From: Sent:	Walker Wrenn <walker@locklearconsulting.com> Monday, November 02, 2015 11:12 AM</walker@locklearconsulting.com>
То:	Morris, John R.
Cc:	Morgan, Steve; Tafuni, Steven; John Locklear
Subject:	RE: MW 15B and 16B [Enterprise CIII landfill, permit #177982-020-SO/T3, facility #87895]
Attachments:	87895_201509_REVISED Groundwater Data.pdf

<u>REVISED</u> GROUNDWATER ELEVATION DATA

Enterprise Class III Landfill and Recycling Facility 2015 - Second Semiannual Compliance Monitoring Event

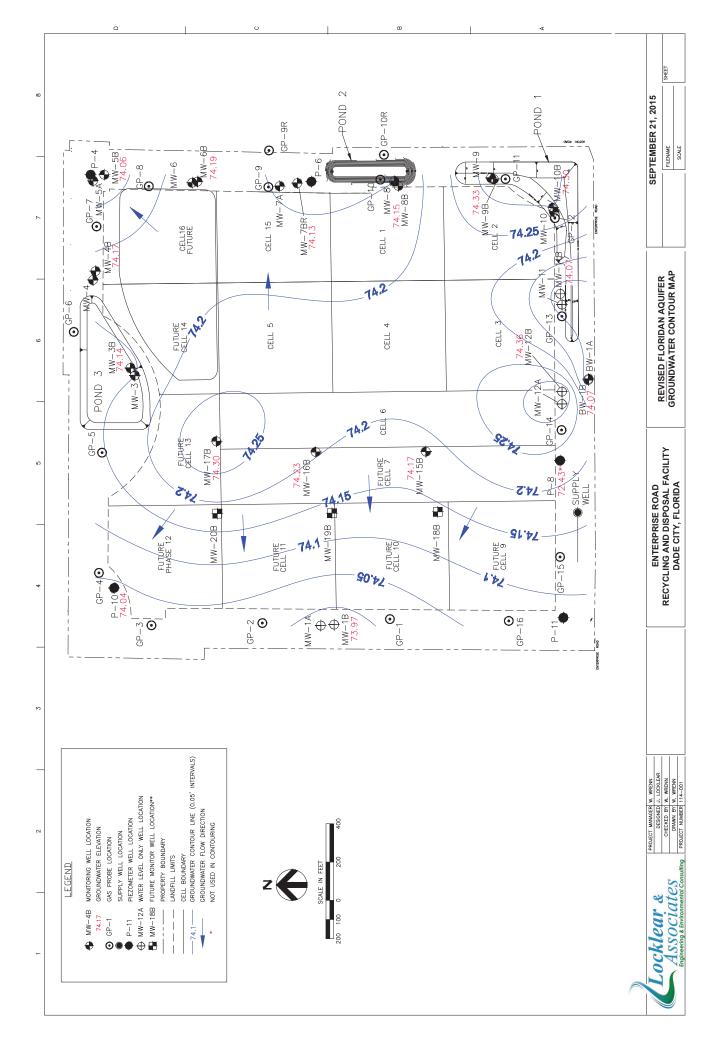
Good morning. I'm reviewing the results of the Sep. 2015 sampling event conducted at Enterprise Class III Landfill that were transmitted via your letter dated Oct. 19, 2015. The ground water elevations reported for wells MW-15B and MW-16B appear to considerably higher than expected. An excerpt from the ground water elevation table for the Sep. 2015 event follows:

The e-mail chain below initiated by John Arnold during June 2015 requested approval to cut the riser pipe of wells MW-15B and MW-16B as the surrounding area continues to be excavated. As highlighted in my message below, I requested the wells be re-surveyed to establish new measuring point elevations. Please submit a copy of the survey that provides the new elevations for these wells. Please also submit a revised summary table for water levels measured during Sep. 2015 and a revised Floridan aquifer contour map for Sep. 2015 that includes the recalculated elevations for wells MW-15B and MW-16B.

Please see the attached REVISED summary table for water levels measured during Sep. 2015 and REVISED Floridan aquifer contour map for Sep. 2015 that includes the recalculated elevations for wells MW-15B and MW-16B. The 10-07-2015 survey is included in the attachment. The final page of the attachment describes that the TOCs were too high to measure elevations so additional pipe was cut by the surveyor. As always, please don't hesitate to contact me if you have any questions.

- 100.00 Datum Mark on Well Surveyed by Simmons and Beall (10/7/15)
 - 9.65 Length of Pipe Removed (sticking up from survey datum...too high to survey TOC)
- 109.65 Computed Top of Casing at Sampling Event (2nd 2015)
- 35.42 Depth to Water at Sampling Event (2nd 2015)
- 74.23 Groundwater elevation

- 103.97 Datum Mark on Well Surveyed by Simmons and Beall (10/7/15)
- 13.25 Length of Pipe Removed (sticking up from survey datum...too high to survey TOC)
- 117.22 Computed Top of Casing at Sampling Event (2nd 2015)
- 43.05 Depth to Water at Sampling Event (2nd 2015)
- 74.17 Groundwater elevation
